AMENDMENTS TO THE DRAWING FIGURES

(Serial No. 10/696,791)

REMARKS

Fig. 3A

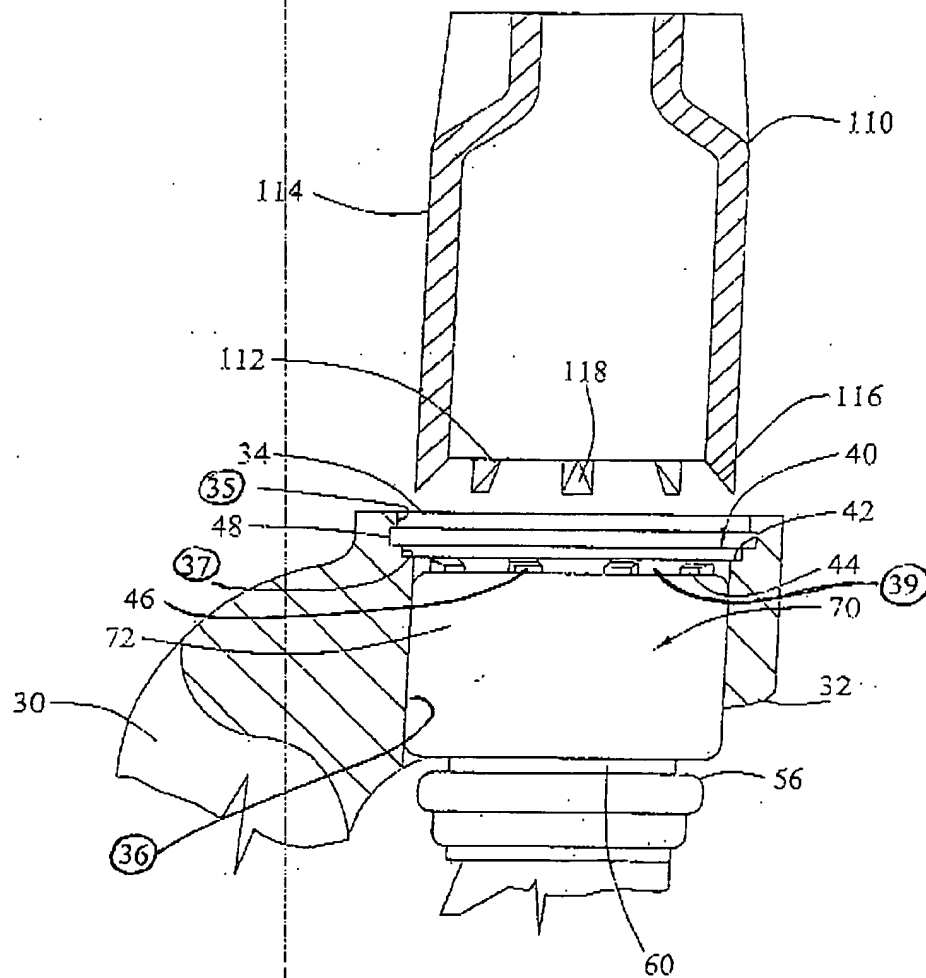
The attached Replacement Sheet contains changes to FIG. 3A. Those changes are marked in red on the Annotated Sheet Showing Changes, which is an appendix to this amendment.

Claims 1-3 and 5-7 stand rejected under 35 U.S.C. 112, first paragraph, for not being satisfactorily described in the specification. Amended Paragraph [0028] and FIG. 3A, taken together, describe and illustrate the location of the "first diameter," "second diameter," "third diameter," "seat," which replaces "shoulder" in the claims, and the "space" 39. Each of these elements is recited in the claims, as amended. The amended specification supports the claims consistently with the statutory requirement. No new matter has been added.

Claim 1, line 11 has been amended such that the third diameter is smaller than the second diameter. These changes overcome the bases for the rejection.
